**WASTE EVALUATION & ENFORCEMENT BRANCH CHIEF
ACTION REQUEST**

Decision Subject: Consideration of an extension request of one year beyond two years of a Compliance Schedule for California Street Landfill, San Bernardino County (36-AA-0017), a facility included on the Inventory of solid waste facilities which violate State Minimum Standards (Inventory)

Subject: CALIFORNIA STREET LANDFILL, SAN BERNARDINO COUNTY (36-AA-0017)
LANDFILL GAS REMEDIATION PLAN
REVIEW COMMENTS

SCS ENGINEERS ENVIRONMENTAL CONSULTANTS 35 CAJON STREET, SUITE 222 REDLANDS, CA 92373	SHEET TITLE: SVE LAYOUT	NO. FOR CLIENT REVIEW: 2	REVISION: 2-12-16	DATE: 2-12-16
	PROJECT TITLE: 2016 SVE WELL INSTALLATION CALIFORNIA STREET LANDFILL 2151 NEVADA STREET REDLANDS, CA 92373	FIGURE 1

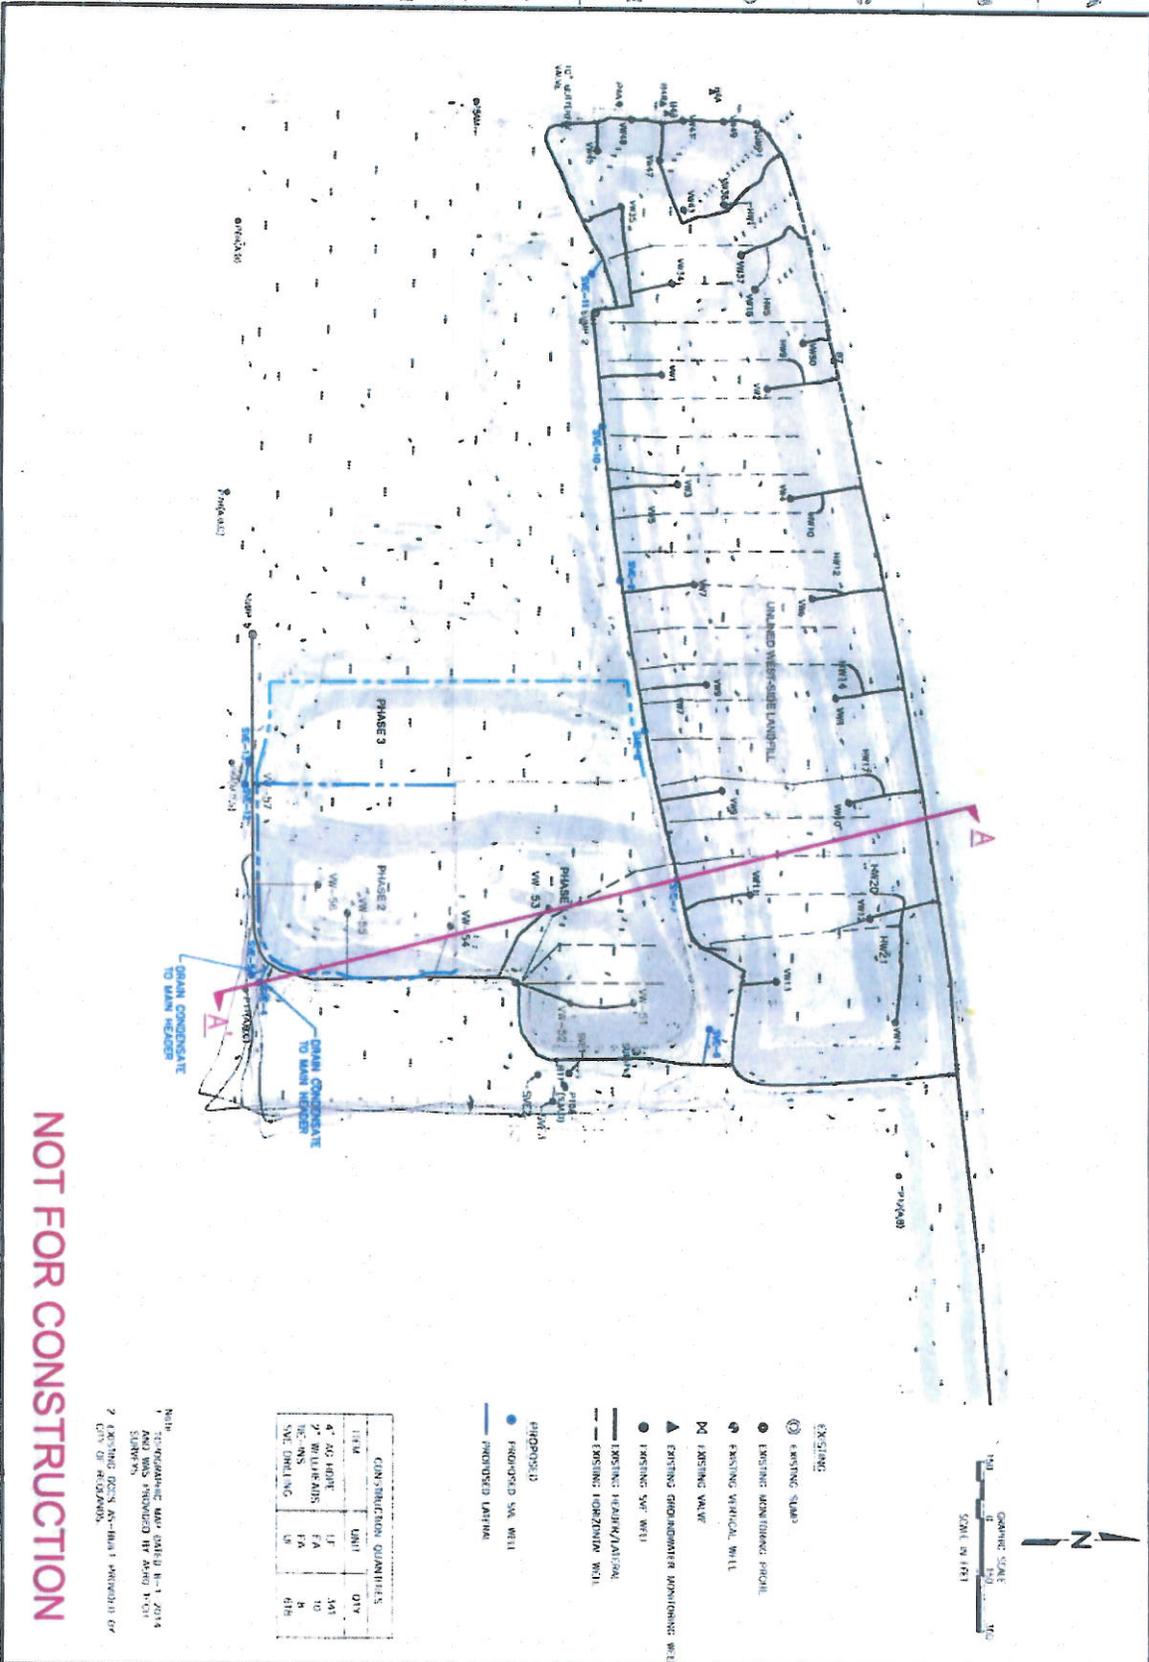
The Plan proposes that ten soil vapor extraction (SVE) wells be installed: four near monitoring wells P-8A and P-11 and six along the southern edge of the unlined waste cell. While the Plan states that the SVE wells should mitigate the methane exceedances, the Plan also notes that the ideal solution would be to install additional LFG extraction wells in the waste mass fill areas in both the lined and unlined areas.

ESB staff is concerned about the installation of SVE wells in close proximity to the impacted monitoring wells (P-8A and P-11). Should the SVE wells produce a vacuum or otherwise impact the efficacy of the monitoring wells, the monitoring wells could no longer be considered adequate for migration monitoring and would need to be replaced. The use of SVE wells for a limited time period (a few months) may be acceptable for removing LFG that has already migrated, but SVE wells that impact monitoring wells shall not be considered a long term solution. While ESB staff does not object to the temporary use of the SVE wells near the monitoring wells, staff concurs with the Plan that the ideal solution would be additional extraction wells.
